400 KHz Voltage/Max Depth

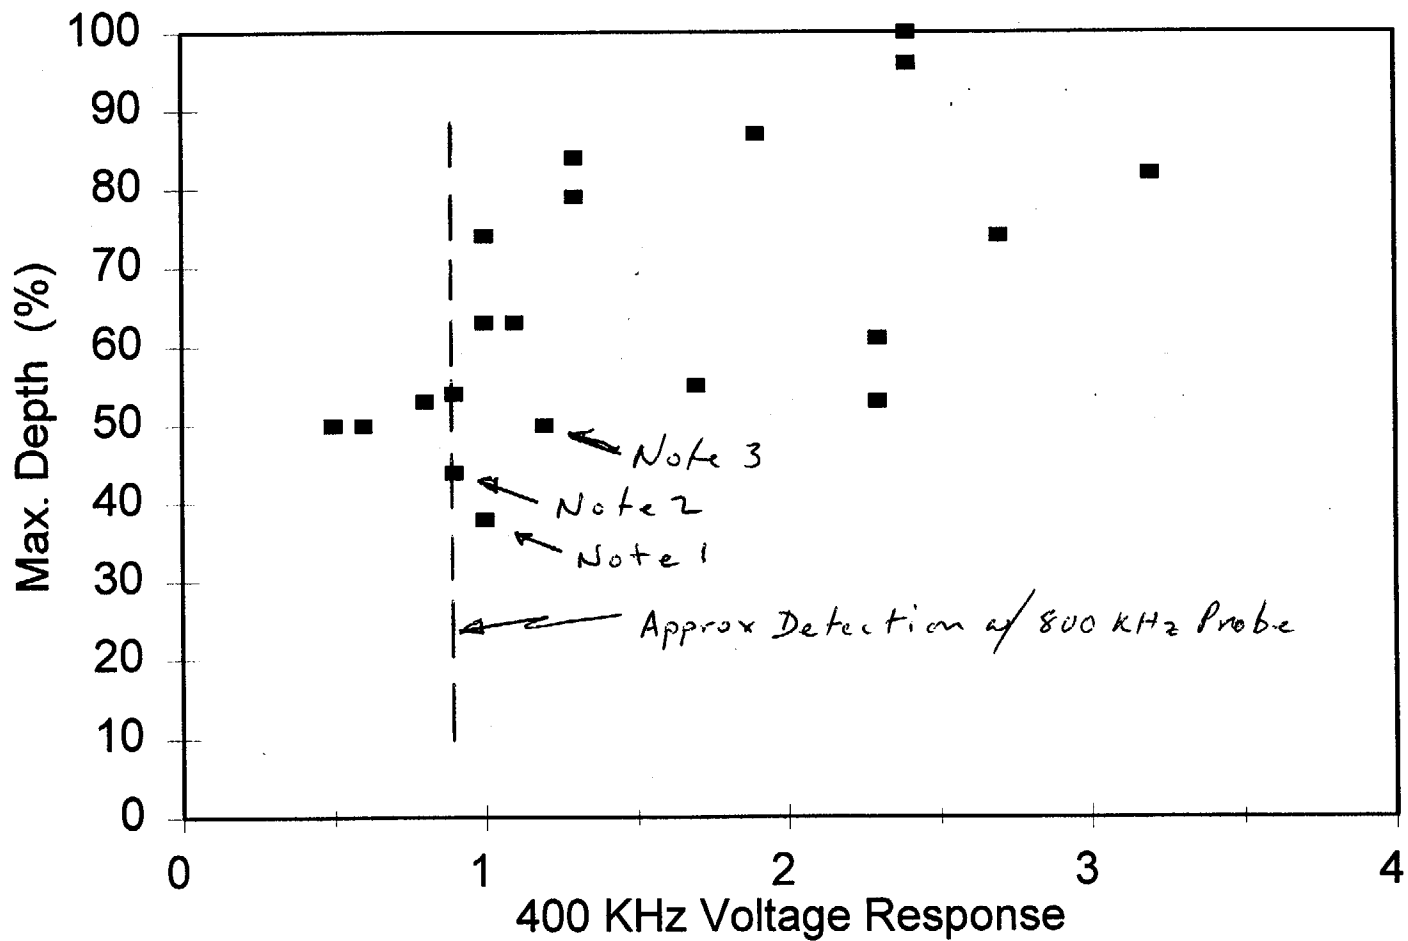
1. Westinghouse profile at 800 KHz indicates max depth of 53%. C. Dodds profile at 800 KHz indicates max depth of 85%. Dodd was more correct, since the tube leaked at 4800 psi
2. Westinghouse profile at 800 KHz indicates max depth of 50%. C. Dodds estimates max depth of 65% and 63% at 800 KHz and 300 KHz respectively.
3. Westinghouse and Dodd estimate max depth around 70% at 800 KHz.

400 KHz Voltage/Ave. Depth

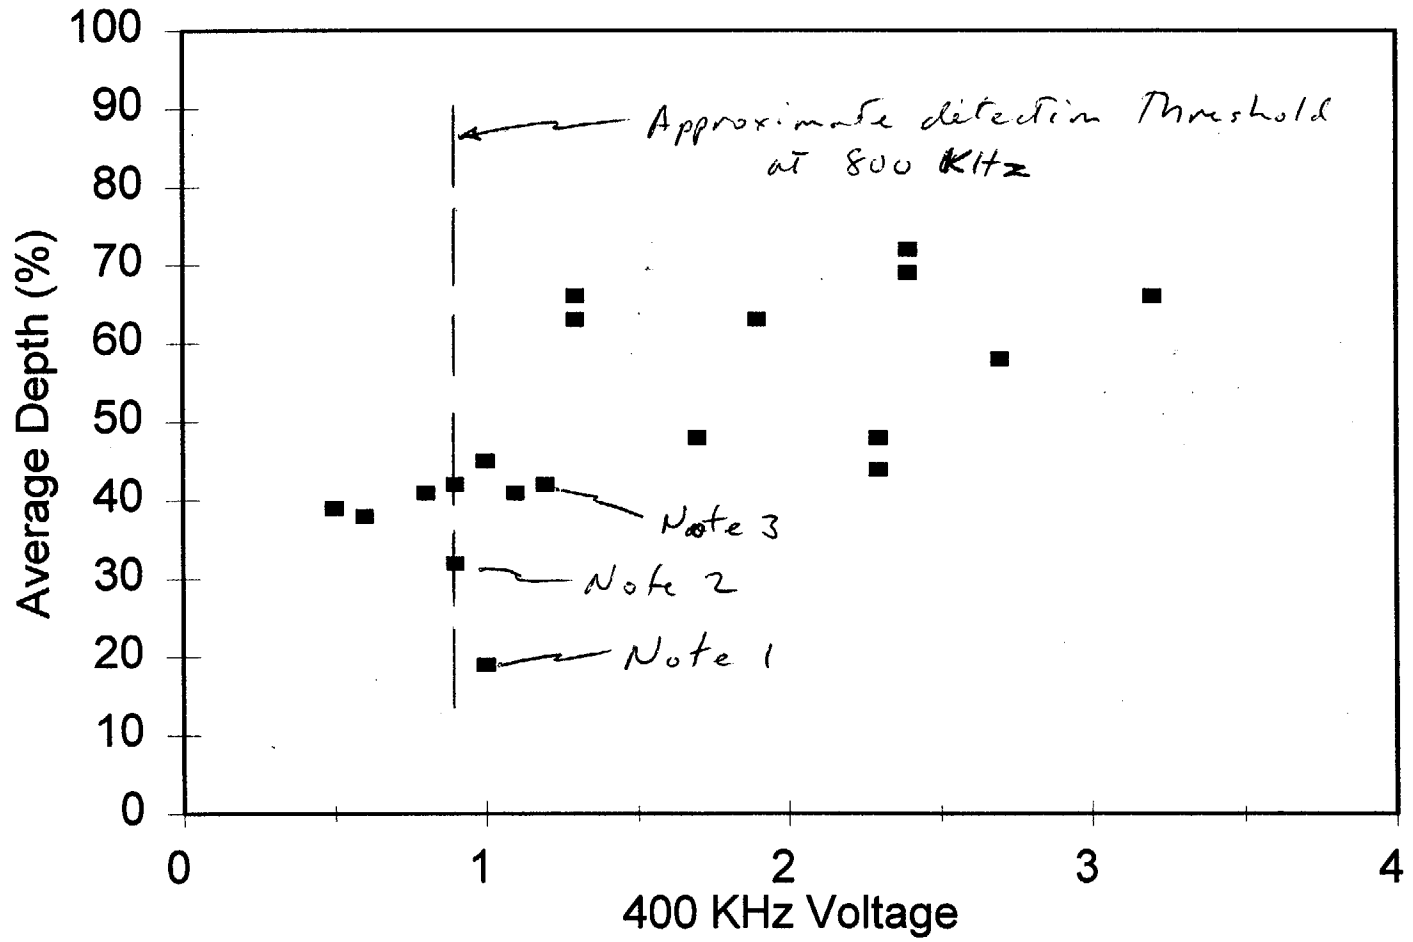
1. This data point indicates 19% aver depth over burst effective length of .11 inches. This tube leaked at 4800 psi. So the average depth over this distance must be 90% or more.
Westinghouse profile at 800 KHz indicates aver depth of 39% over BElength of .16 inches. C. Dodd's profile at 800 KHz indicates aver depth of 52% over BE length of .35 inches with max depth of 85%.
2. C. Dodds estimates aver depth of 45% and 50-55% at 800 KHz and 300 KHz respectively.
3. C. Dodd estimates aver depth of 60% at 800 KHz.
